# Addendum No. Two

RFP No: FY24-805-45 A

Airport Terminal Building Improvements AWIP : BHS-TC2/TC4 : A-Wing Offices

This Addendum # 2 to Request for Bids for Airport Terminal Building Improvements AWIP : BHS-TC2/TC4 : A-Wing Offices contains the following responses to bidder inquiries and clarifications or changes to the Bid Documents:

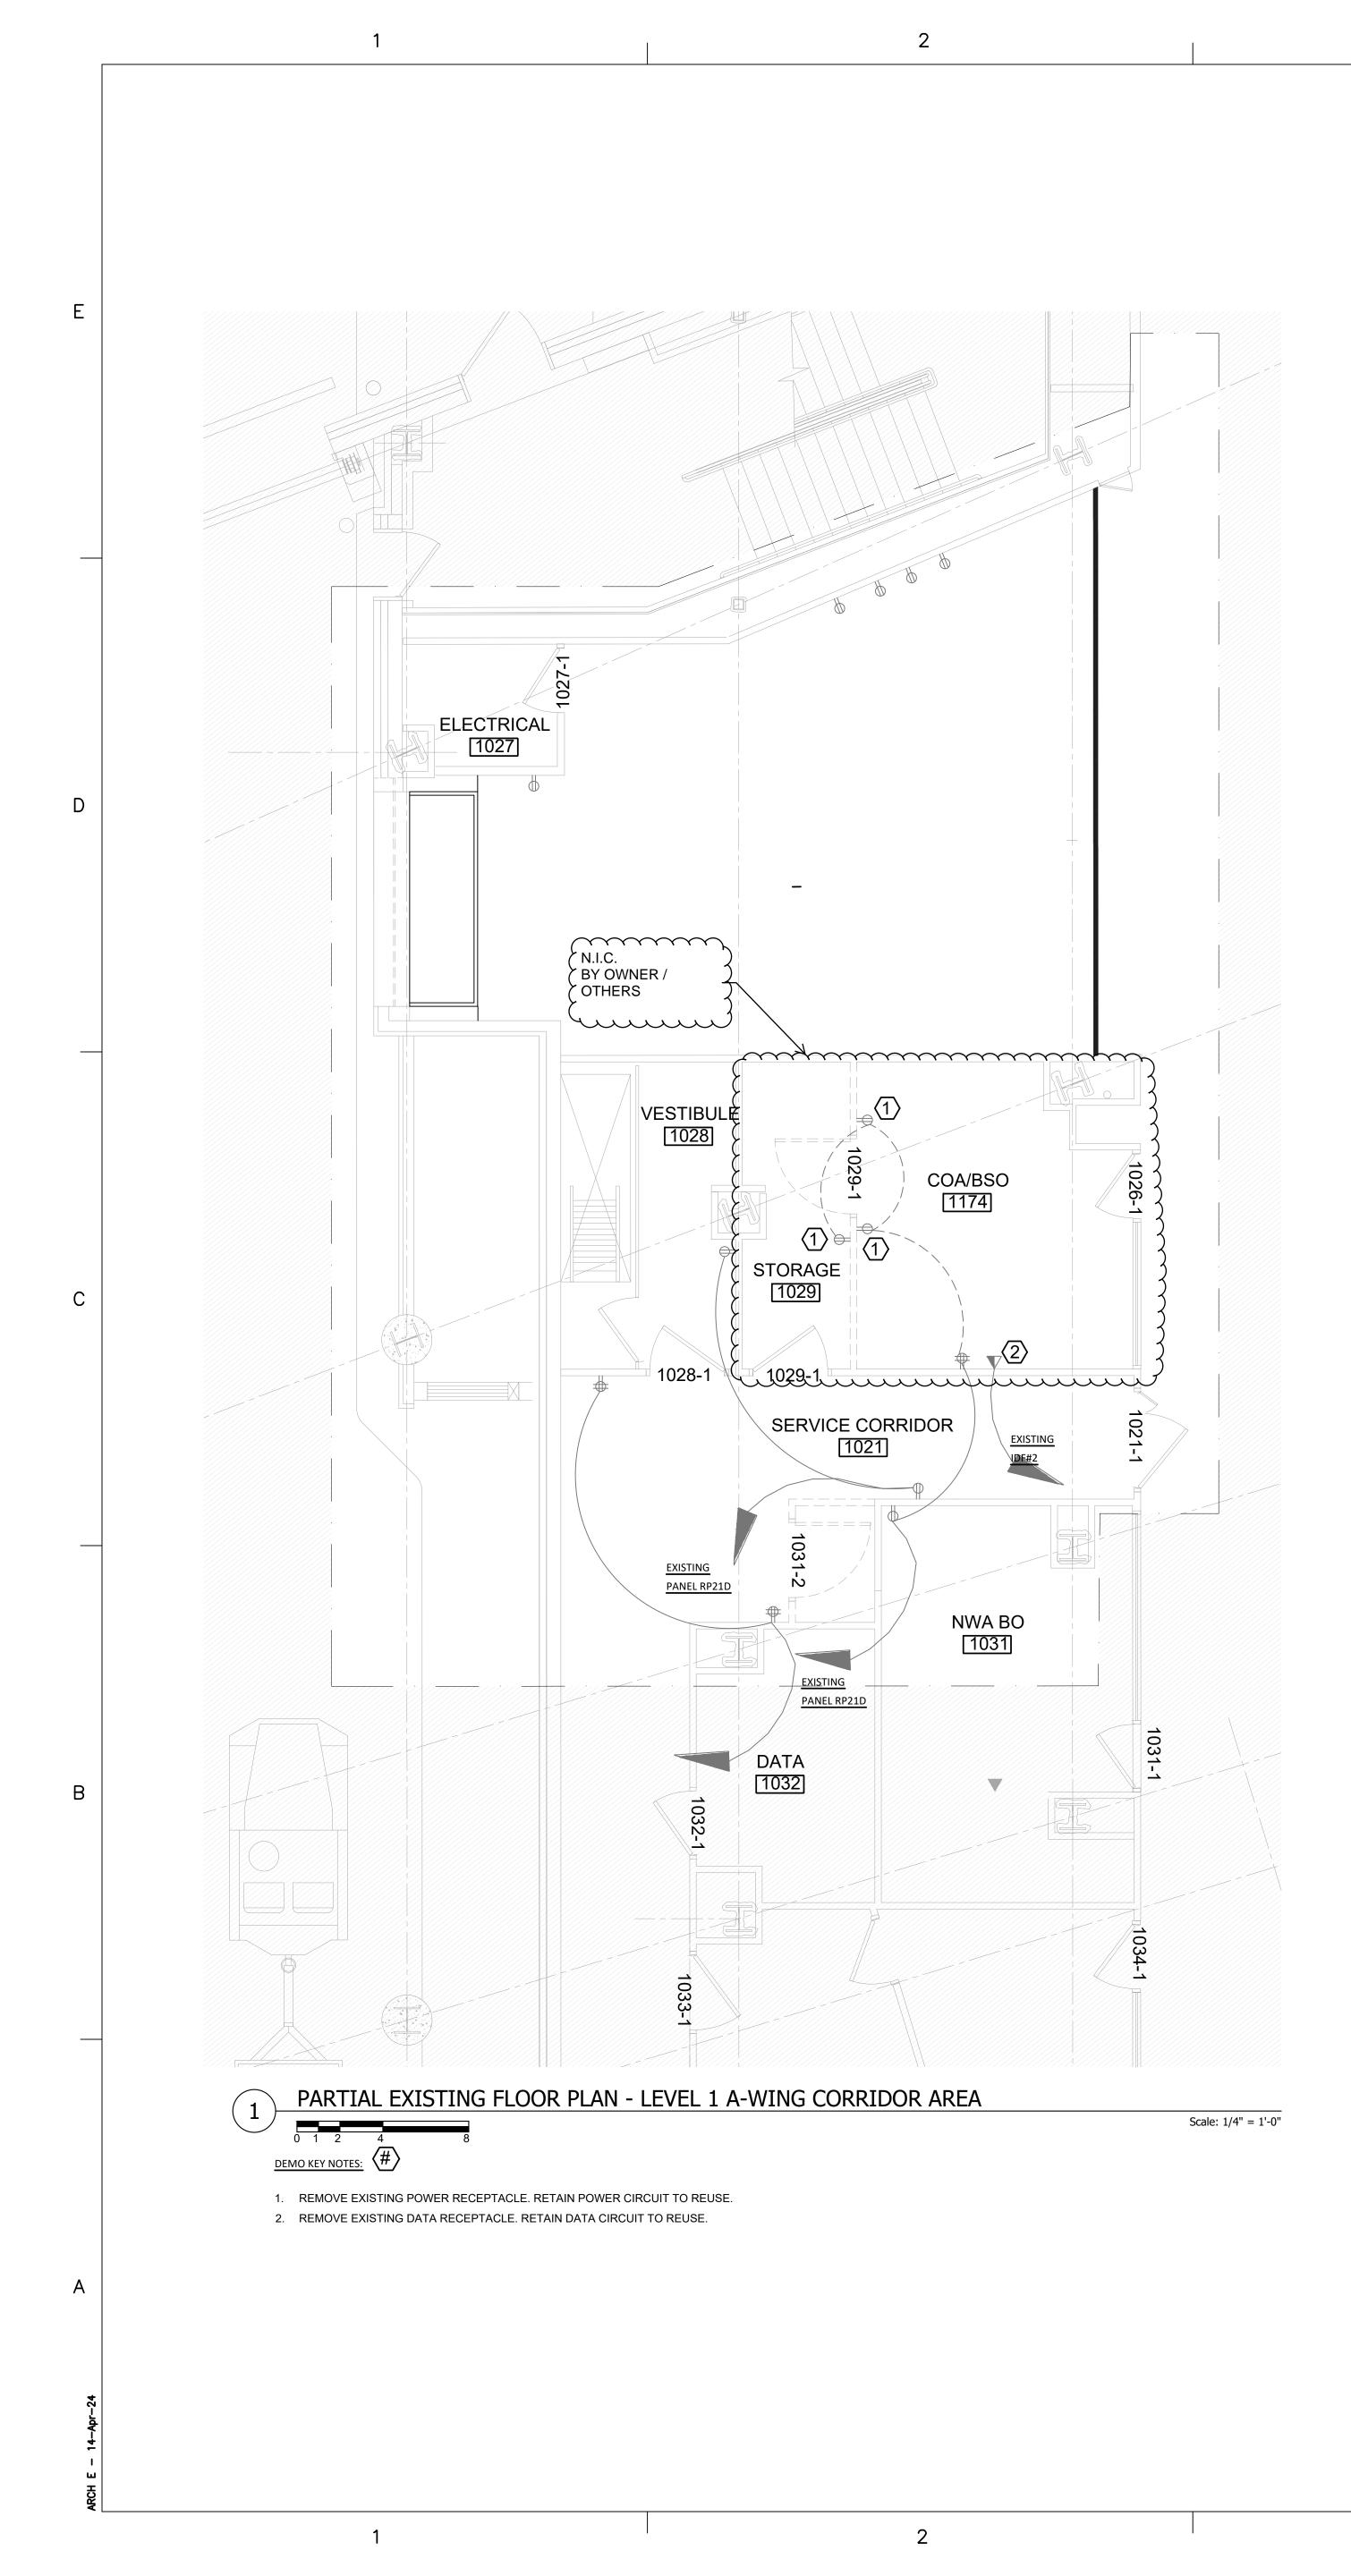
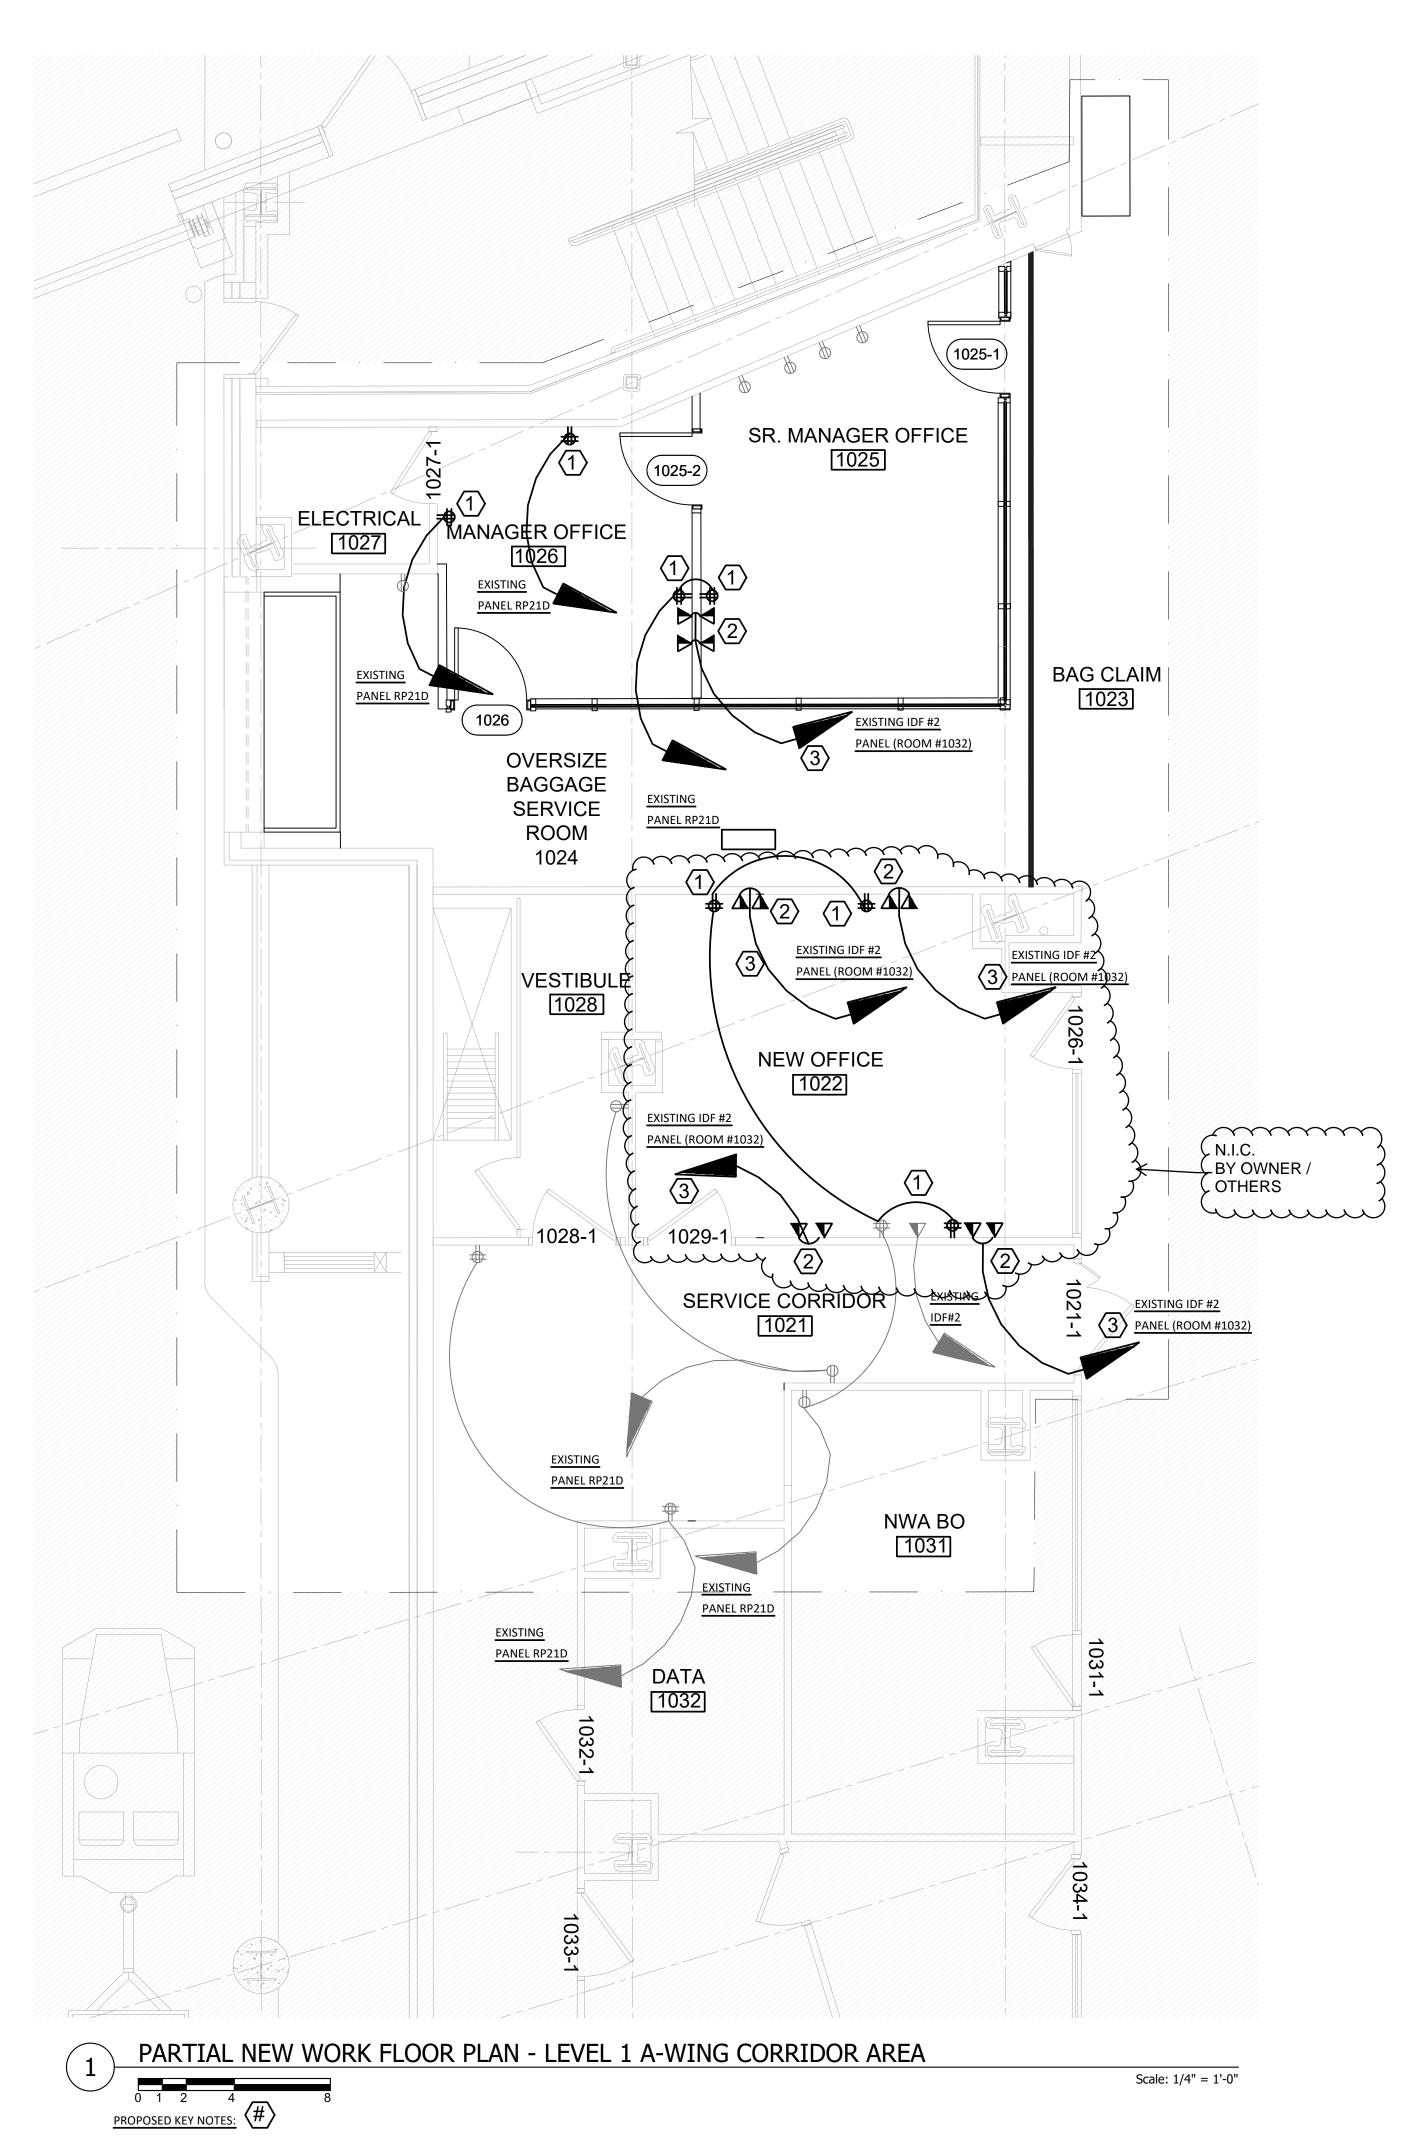
- 1. EXISTING SUPPLY AIR DIFFUSER TO BE DEMOLISHED.
- 2. EXISTING SUPPLY AIR DIFFUSER TO BE RELOCATED WITHIN THE SAME SPACE.
- 3. EXISTING SUPPLY AIR DIFFUSER TO REMAIN.
- 4. RELOCATED SUPPLY AIR DIFFUSER.
- 5. PROVIDE 24"X24" NEW CEILING AIR DIFFUSER TO SUPPLY 220 CFM. PROVIDE Ø8" RIGID AND FLEXIBLE DUCT TO CONNECT THIS DIFFUSER TO THE EXISTING DUCT WORK. EXTEND FLEXIBLE DUCT UP TO 6 FEET LENGTH.
- 6. PROVIDE 24"X24" NEW CEILING AIR DIFFUSER TO SUPPLY 170 CFM. PROVIDE Ø8" RIGID AND FLEXIBLE DUCT TO CONNECT THIS DIFFUSER TO THE EXISTING DUCT WORK. EXTEND FLEXIBLE DUCT UP TO 6 FEET LENGTH.
- 7. PROVIDE 24"X24" NEW CEILING MOUNTED RETURN AIR GRILLE.
- 8. EXISTING 10"X6" RETURN AIR GRILLE TO REMAIN.
